**Re: Design Submission for Lands at Belgard Road, Cookstown, Dublin (the “Development”)  
(the “Design Submission”) / Connection Reference No: CDS20005423**

We have reviewed your proposal for the connection(s) at the Development. Based on the information provided, which included the documents outlined in Appendix A to this letter, Irish Water has no objection to your proposals.

- BR-CSC-ZZ-00-DR-C-0005 Proposed Foul and Surface Water Drainage - Ground Level\_P2
- BR-CSC-ZZ-00-DR-C-0006 Proposed Watermain\_P2
- BR-CSC-ZZ-XX-DR-C-0027\_Foul Sewer Longsections

PROPOSED WATERMAIN  
SCALE= 1:250

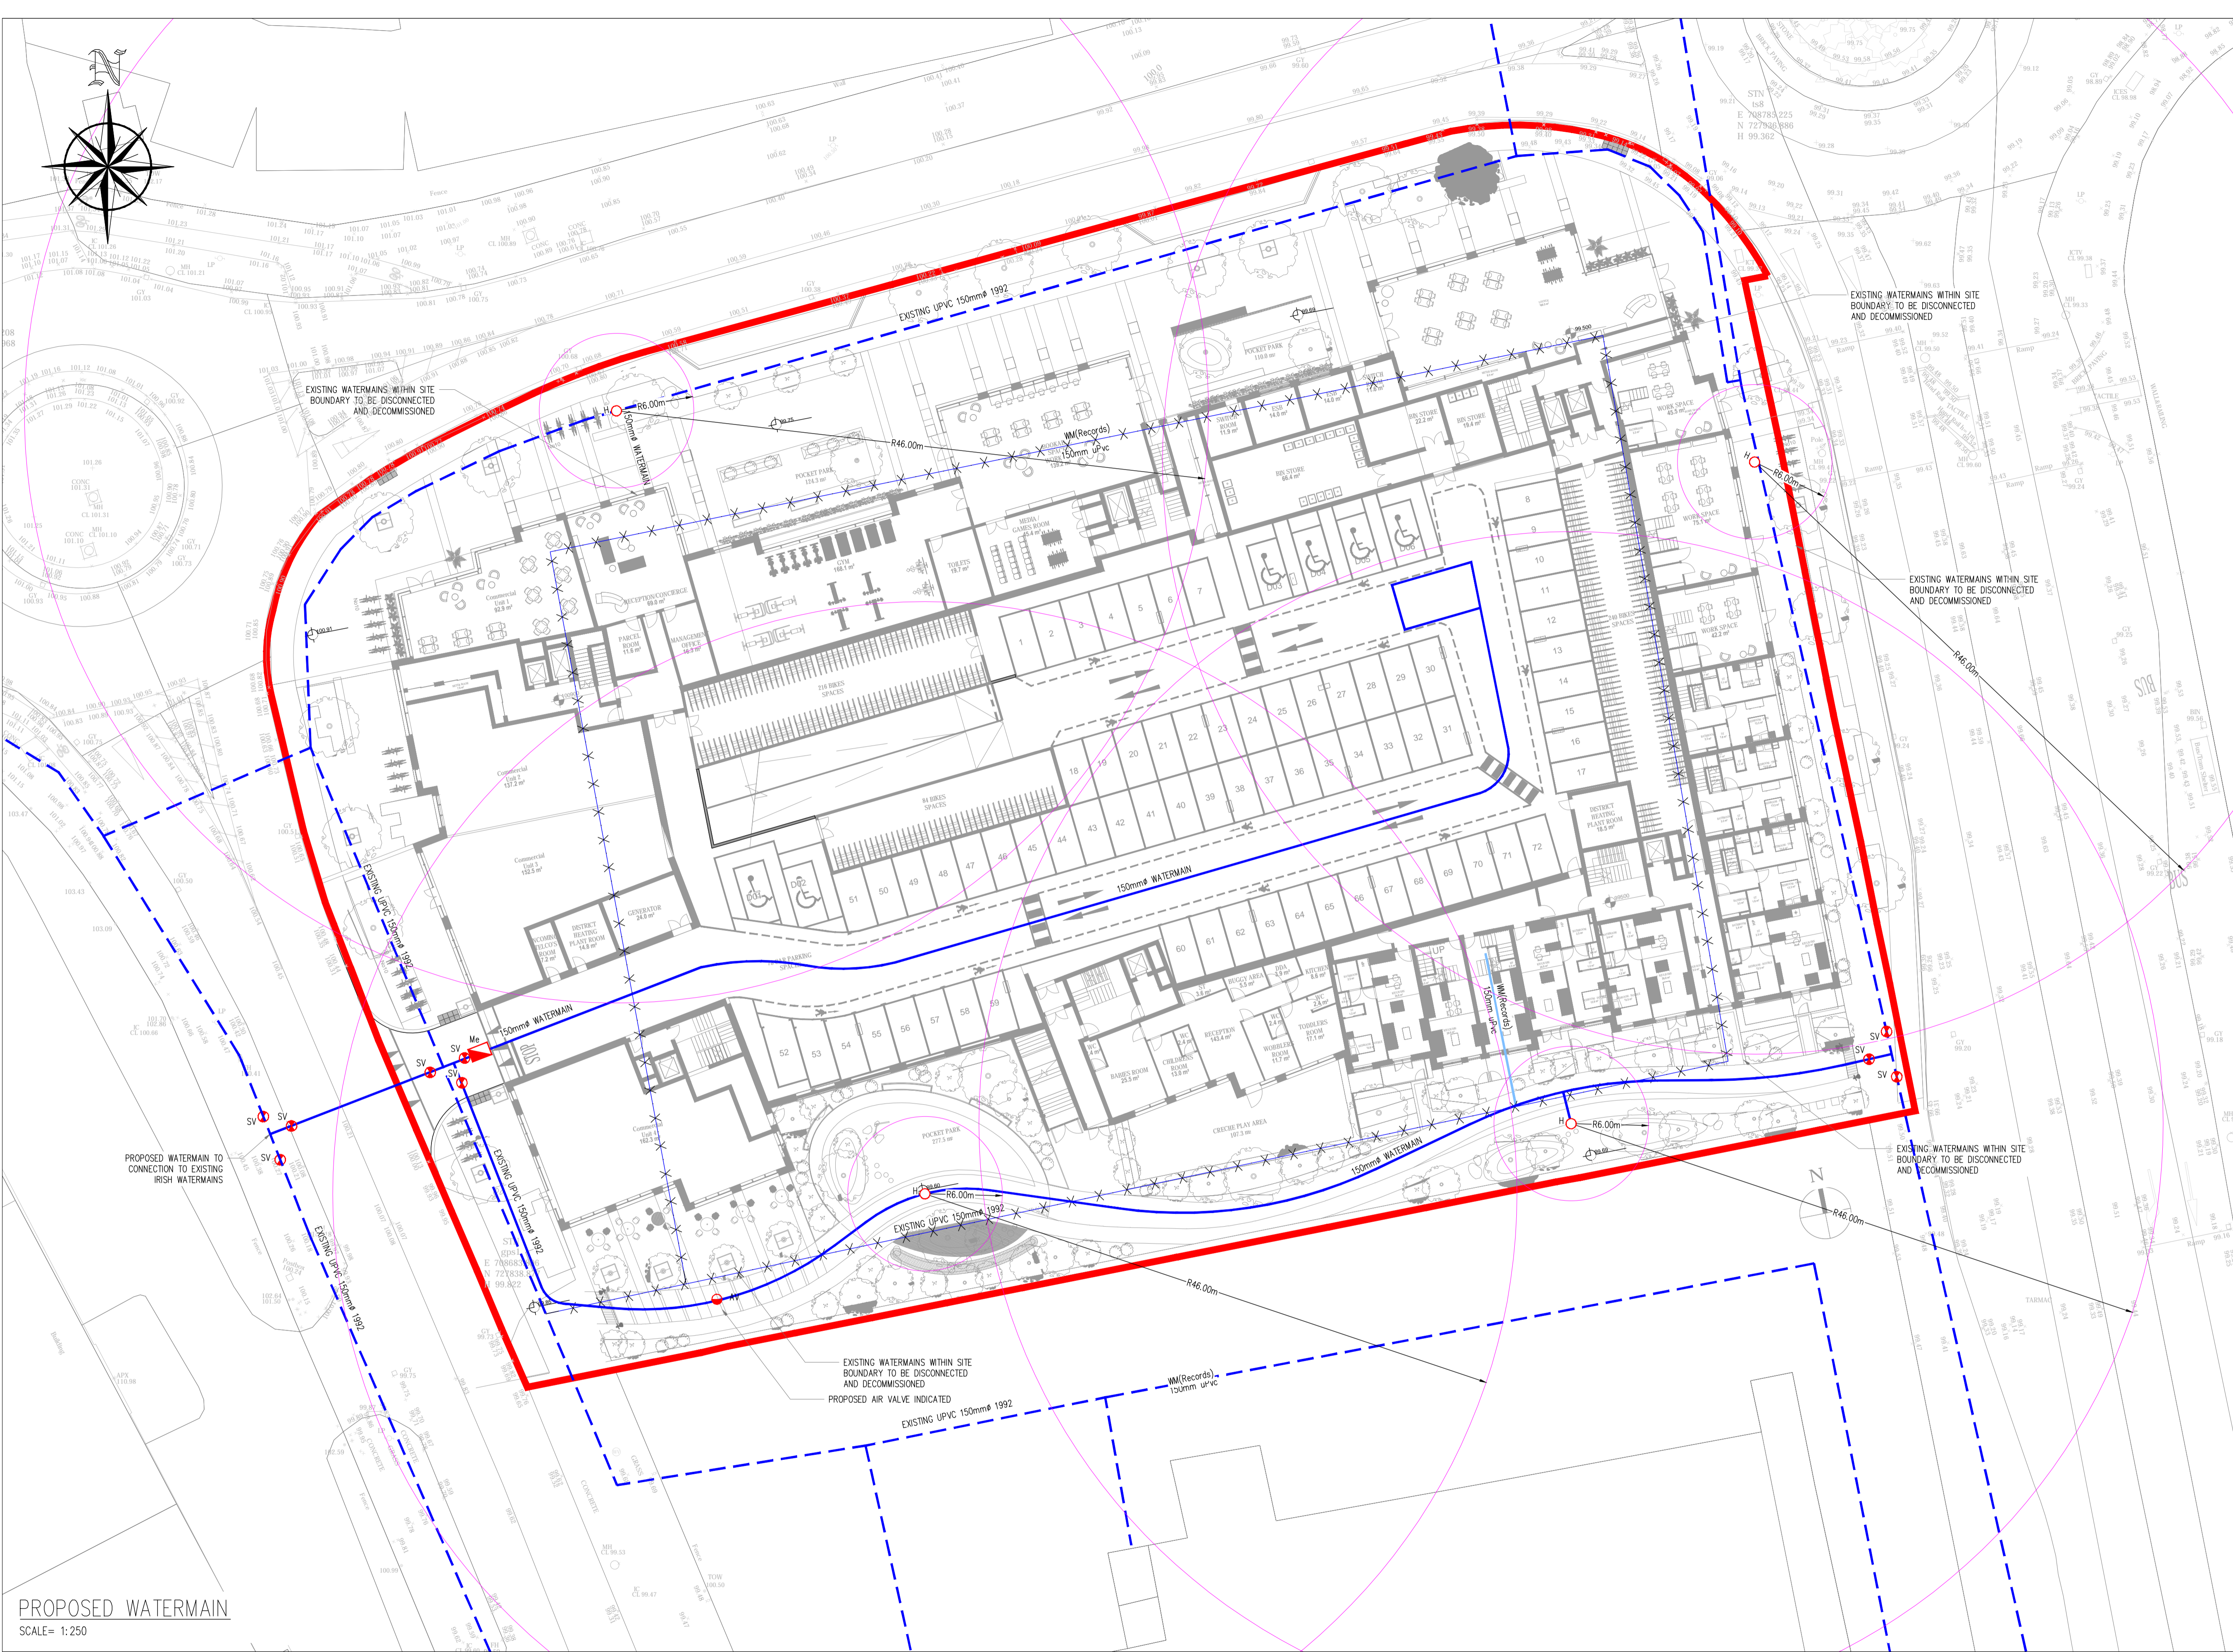
While Irish Water notes that the water and wastewater services infrastructure will remain private and not be vested, we have the following comments: It is recommended that loops shall have a minimum of four connected houses and one hydrant.
